# UNITED STATES PATENT AND TRADEMARK OFFICE

10/533,550

<b>Office Action Summary</b>	<b>Application No.</b> 10/533,550	<b>Applicant(s)</b> GRAHAM ET AL.	
	<b>Examiner</b> ANDRES LOPEZ ESQUERRA	<b>Art Unit</b> 2818

## **DETAILED ACTION**

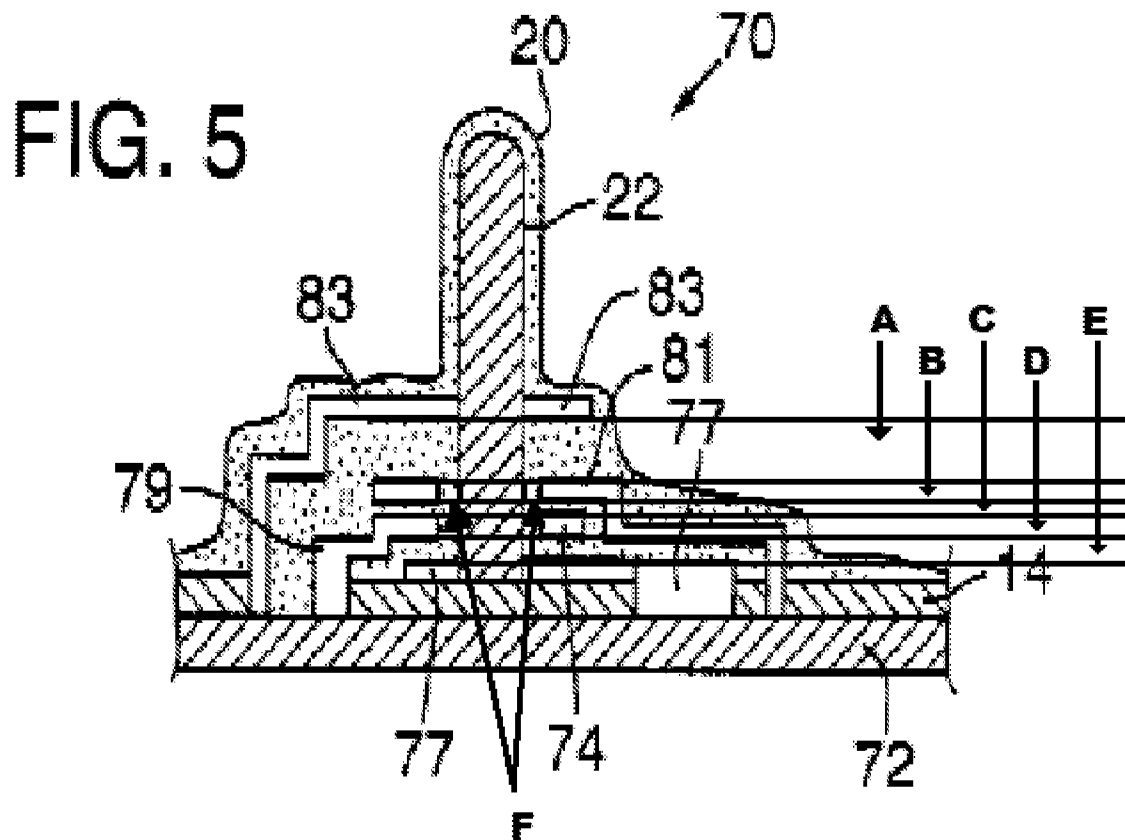
13. As for claims 22, 41, and 44, Farnworth discloses (Col. 7, lines 29 – 38) and show sin Fig. 5 vertically integrated field-effect transistor comprising:

- a. a first electrically conductive layer (77);
- b. a middle layer (A, C, E), formed partially from dielectric material, on the first electrically conductive layer;
- c. a second electrically conductive layer (83) on the middle layer;
- d. and a nanostructure (22) integrated in a via hole introduced into the middle layer, the nanostructure further comprising a first end portion that is

coupled to the first electrically conductive layer and a second end portion that is coupled to the second electrically conductive layer (Fig. 5),

e. wherein the middle layer, between two adjacent dielectric sublayers, has a third electrically conductive layer (B), the thickness of which is less than the thickness of at least one of the dielectric sublayers (Fig. 5) (thickness of A is greater than B); and

f. wherein a ring structure (F) (the ring is formed from the insulation layer around the nanostructure) formed from an electrically insulating material as gate-insulating region of the field-effect transistor is arranged in the third electrically conductive layer, along the via hole that has been introduced therein,

g. wherein the middle layer has an additional electrically conductive layer (D), which at least one additional electrically conductive layer serves as an additional gate electrode of the field-effect transistor, with an additional ring structure formed from an electrically insulating material as an additional gate-insulating region of the field-effect transistor being arranged along the via hole that has been introduced in the additional electrically conductive layer.

Figure 2

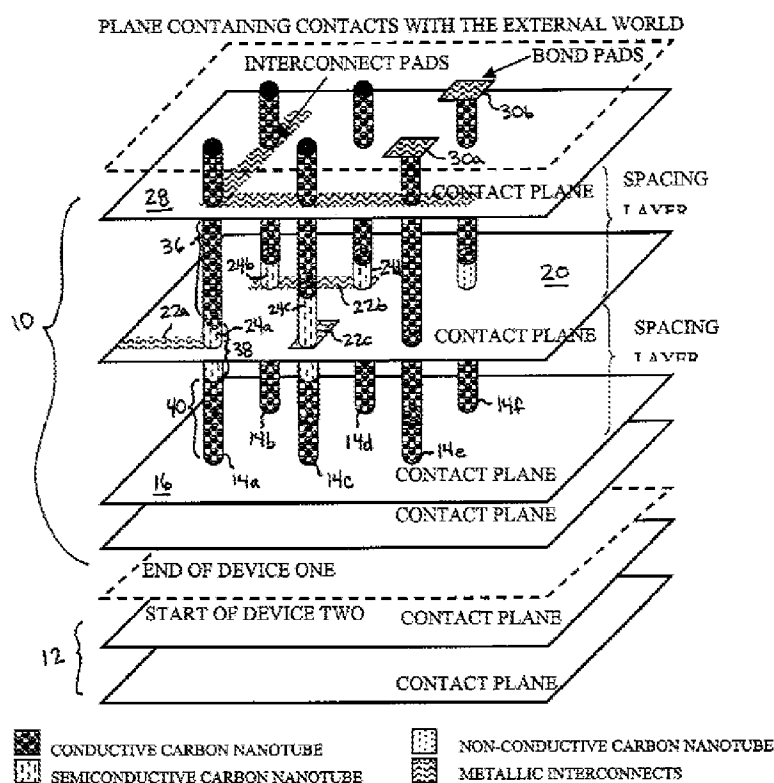
**20. As for claims 22 and 41 – 43, Mancevski discloses (Page 3 [0040]) and shows in Fig. 2 a carbon nanotube transistor and method of manufacturing the same comprising:**

- h. a first electrically conductive layer (16);
  - i. a middle layer /spacing layers(10), formed partially from dielectric material, on the first electrically conductive layer;

- j. a second electrically conductive layer on the middle layer (28), and;
  - k. a nanostructure (14) integrated in a via hole/vertically aligned holes introduced into the middle layer, the nanostructure further comprising a first end portion that is coupled to the first electrically conductive layer and a second end portion that is coupled to the second electrically conductive layer (as shown in the Fig, 2 both ends of the nanotubes are imbedded in the contact layer);

- l. wherein the middle layer, between two adjacent dielectric sublayers/spacing layers, has a third electrically conductive layer (20), the thickness of which is less than the thickness of at least one of the dielectric sublayers (as shown in Fig 2, the contact plane is thinner than the spacing layers).

21. Mancevski fails to disclose use of a ring structure formed from an electrically insulating material as gate-insulating region of the field-effect transistor is arranged in the third electrically conductive layer, which forms the gate electrode of the field-effect transistor, along the via hole that has been introduced therein.

28. As for claims 24 – 25, Mancevski shows in Fig. 2 that the third conductive layer/contact layer (20) surrounds the nanostructure in the middle of the transistor as well as it been thinner than both dielectric layer/spacing layers.

30. As for claim 28, Mancevski shows in Fig. 2 that creation of a second transistor (12) next to the original transistor (10).

**FIG. 1**

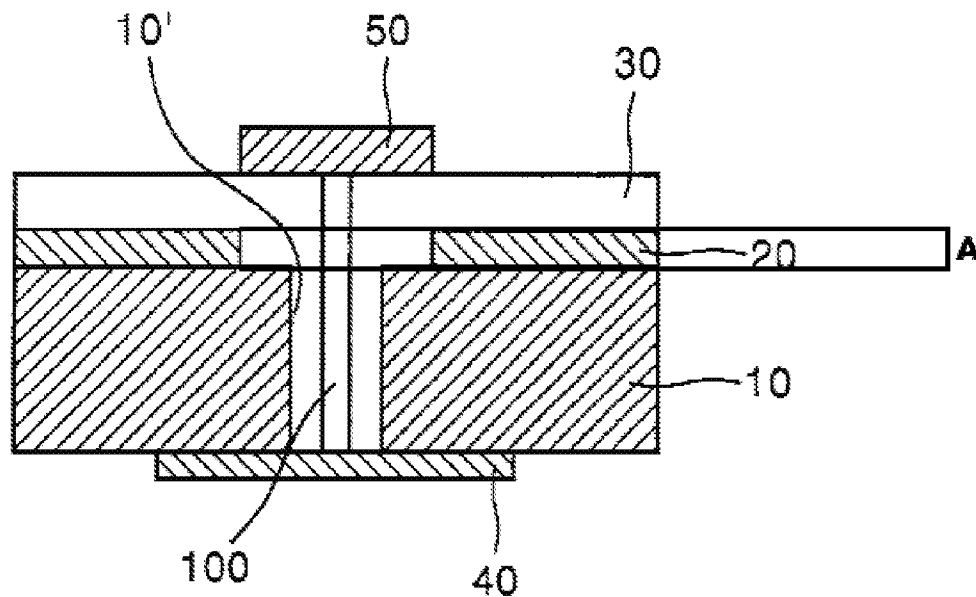
22. Choi discloses (Page 2, [0028]) and shows in Fig. 1 a FET transistor and method of manufacturing the same comprising a nanostructure (100) and the use of an insulation ring (A) in the are of the gate (20) of the transistor.

23. Choi is evidence that ordinary workers in the art would find a reason, suggestion or motivation to use a ring structure in the gate area made of an insulating material.

24. Therefore, it would have been obvious to one of ordinary skill in the art at the time of the invention was made to modify Mancevski by using a ring structure in the gate area made of an insulating material for advantages such as achieving a high-density integration in the final structure of the FET (Page 2, [0028]).

*Fig. 1*

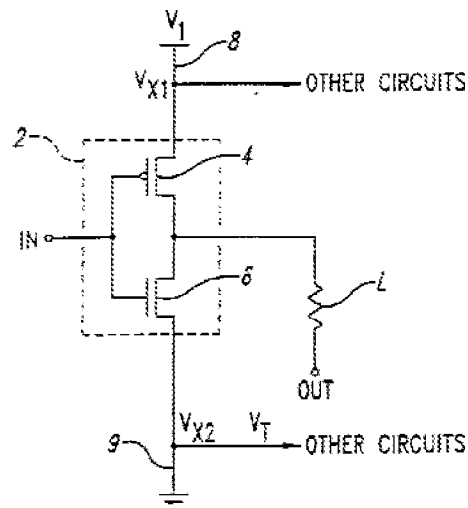
38. As for claim 29, Mancevski discloses the claimed invention except for the use of the transistors as an inverter circuit. It would have been obvious to one of ordinary skill in the art at the time of the invention was made to connect both transistors as a inverter

circuit since it was known in the art that, as evidence in Martin, that the inverter circuit (2) takes the use of two transistors (4,6) connected as in Fig. 1 above. Furthermore, It would have been an obvious matter of intended use to connect both transistors as an inverter circuit, since applicant has not disclosed that this connection solves any stated problem or is for any particular purpose and it appears that the invention would perform equally well in any other circuit with the need of two transistors. Finally, a recitation of "as an inverter circuit" of the claimed invention does not result in a structural difference between the claimed invention and the prior art, thus claimed invention is only an art-recognized suitability for an intended purpose, MPEP 2144.07.
